# HISTORIC AND DESIGN REVIEW COMMISSION

**HDRC CASE NO:** 2021-027  
**ADDRESS:** 520 LEIGH ST  
**LEGAL DESCRIPTION:** NCB 2739 BLK LOT 4F & PT OF 5F (AKA TRACT 6)  
**ZONING:** IDZ,H  
**CITY COUNCIL DIST.:** 1  
**DISTRICT:** Lavaca Historic District  
**APPLICANT:** San Antonio San Antonio/LABOR STREET COMMONS LLC  
**OWNER:** San Antonio San Antonio/LABOR STREET COMMONS LLC  
**TYPE OF WORK:** Construction of a 2-story residential structure, site modifications  
**APPLICATION RECEIVED:** January 15, 2021  
**60-DAY REVIEW:** Not applicable due to City Council Emergency Orders  
**CASE MANAGER:** Stephanie Phillips

The applicant is requesting final approval to construct a new 2-story single family residence at the lot addressed 520 Leigh St.

3 NORTH ELEVATION  
SCALE: 3/16" = 1'-0"

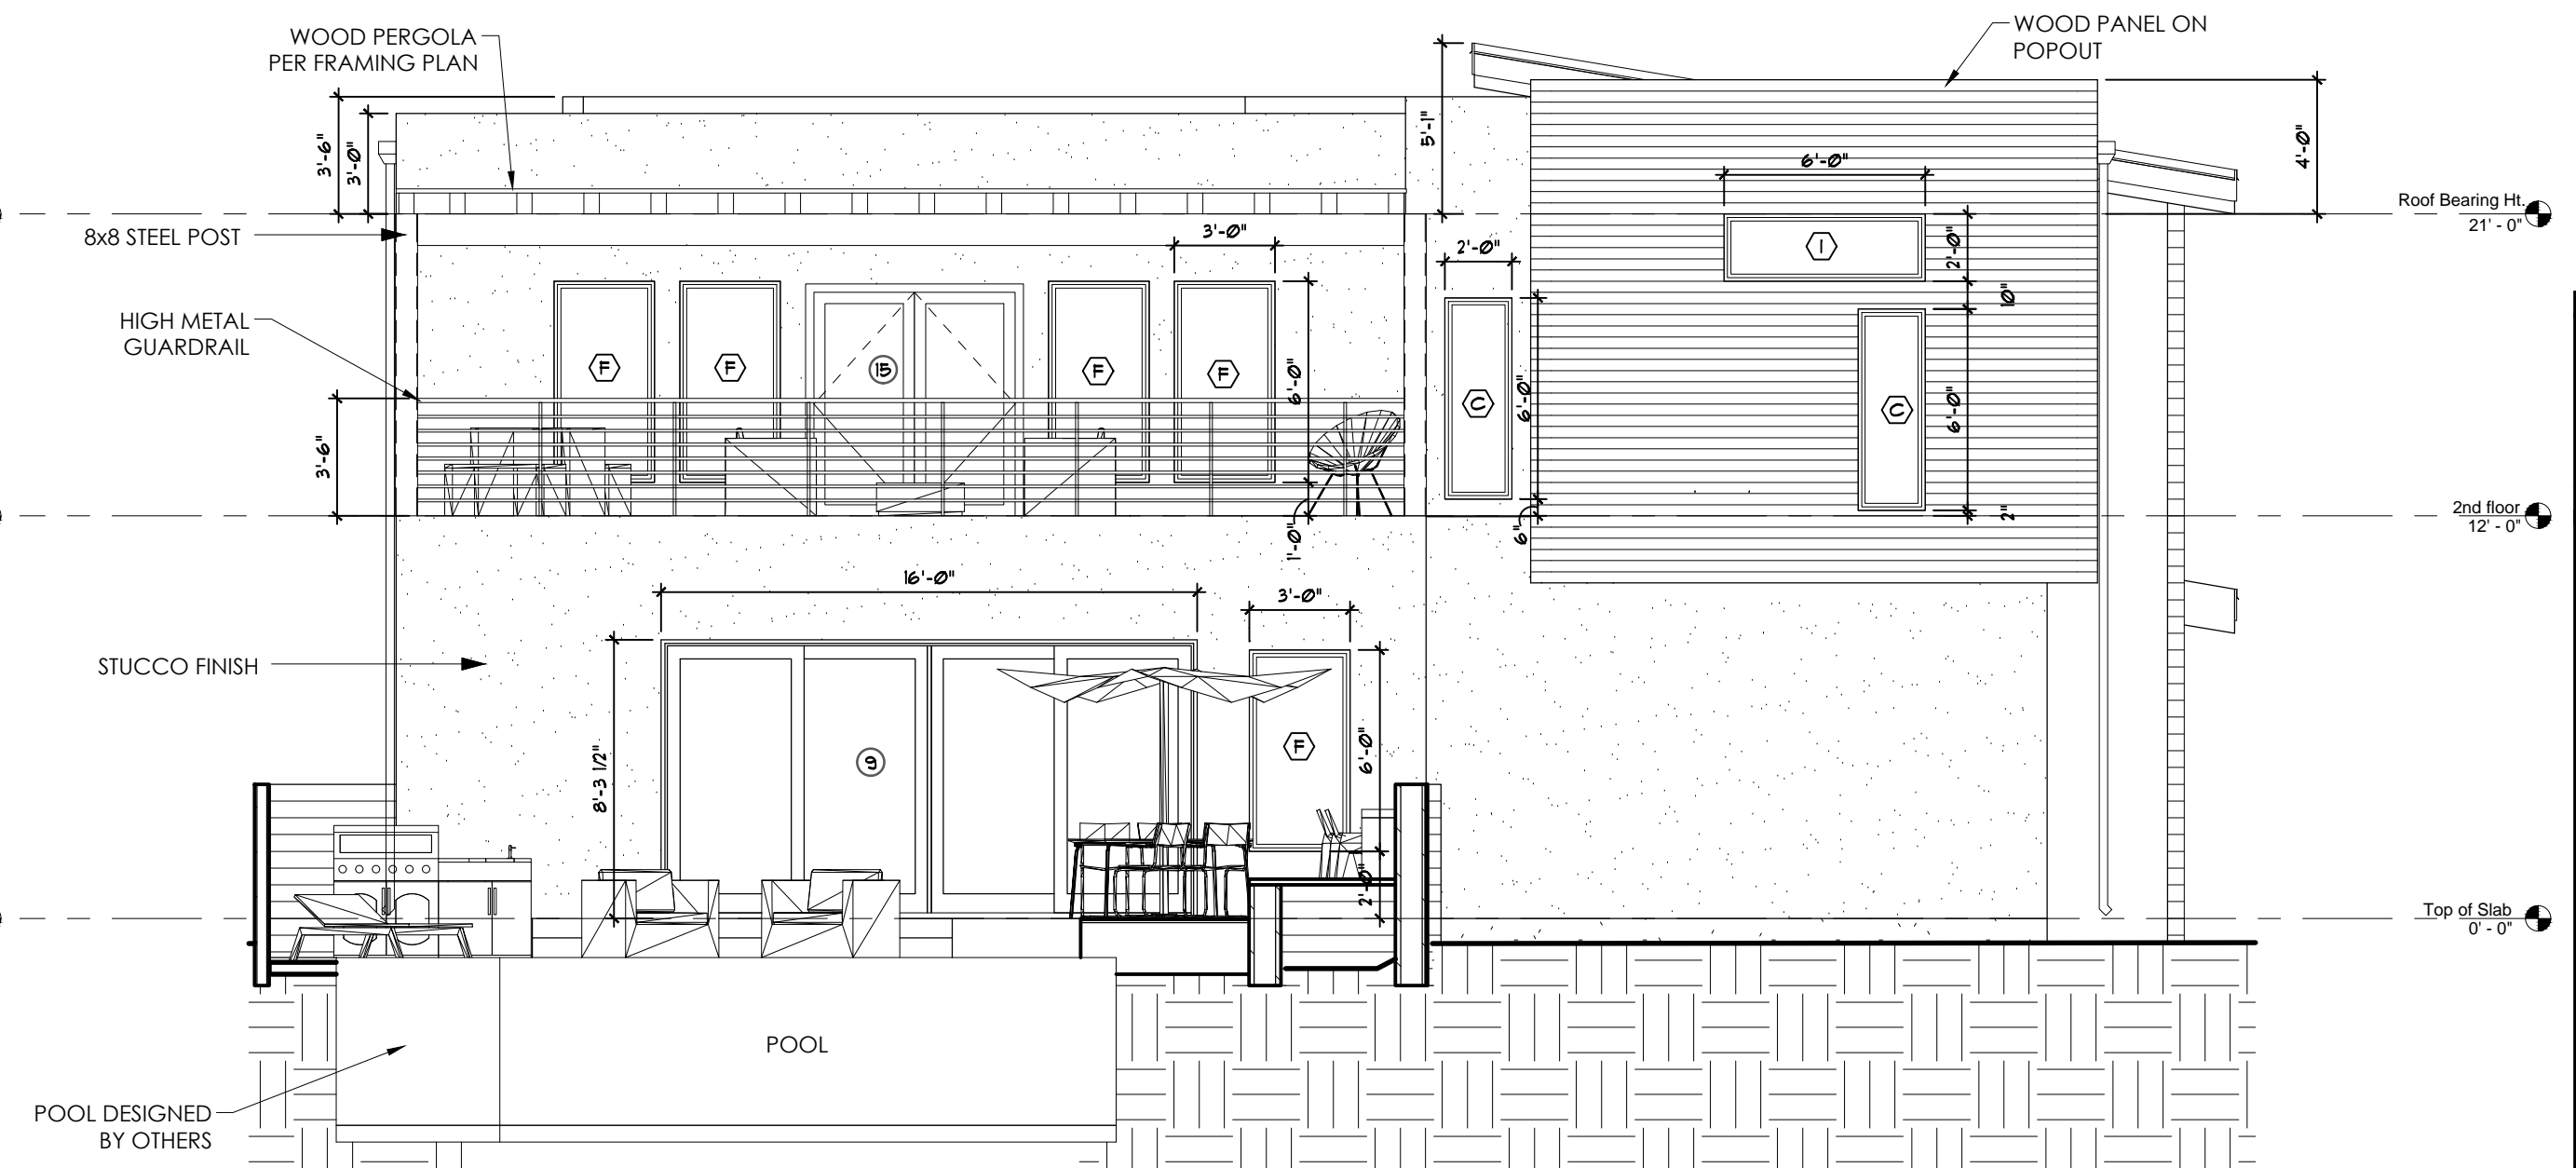
- f. **SCALE & HEIGHT** – Per the Guidelines for New Construction 2.A.i., a height and massing similar to historic structures in the vicinity of the proposed new construction should be used. In residential districts, the height and scale of new construction should not exceed that of the majority of historic buildings by more than one-story. This block of Labor features a 3-story recently constructed structure immediately to the north, as well as multiple historic structures, both residential and commercial, most of which are 1-story. While the proposed height of the new construction may be consistent with the Guidelines given the existence of a two-story historic structure on the block, staff is concerned regarding the proposed proportions of the new construction relative to the development pattern of the lot, which originally featured 1-story structures.

- j. **ROOF FORMS** – The applicant has proposed a multi-slope roofline. The primary roofline will feature a short parapet which will visually read as flat from the public right-of-way with low-sloping shed roofs concealed in the center. A portion of the roof will also feature sheds on the north elevation. Staff generally finds these roof forms to be consistent based on the surrounding context, but finds that in context with the proportions of the home, additional roof solutions should be explored to visually reduce the mass of the flat roof portion, primarily on the north and east elevations.

- k. **WINDOW & DOOR OPENINGS** – Per the Guidelines for New Construction 2.C.i., window and door openings with similar proportions of wall to window space as typical with nearby historic facades should be incorporated into new construction. Per the elevations that the applicant has submitted, staff finds the proposed windows to be inconsistent with the Guidelines. The proposed sizes, configurations, and rhythm are not found historically within the district.

- l. **PORCH MASSING** – The applicant has proposed a front porch that consists of a stoop and roof element that is attached to the front façade of the historic structure. Porches found historically within the district feature massing that is incorporated into the massing of the structure, rather than simply attaching to the front façade,

particularly in the case of two story structures. Staff finds that the proposed porch massing should be incorporated into the overall design of the structure and feature porch configurations and details that are historically found in the district.

- ii. That the proposed structure be reduced in height and massing to be consistent with rear accessory structures found historically within the district (subordinate to primary structures), as noted in findings f and g.

- iii. That the applicant utilize foundation heights that are consistent with the Guidelines, as noted in finding i.
- iv. That the applicant incorporate roof forms that feature matching ridge lines as noted in finding j.

- v. That the applicant incorporate appropriate window sizes and proportions as noted in finding k.
- vi. That the applicant incorporate appropriate porch massing as noted in finding l.
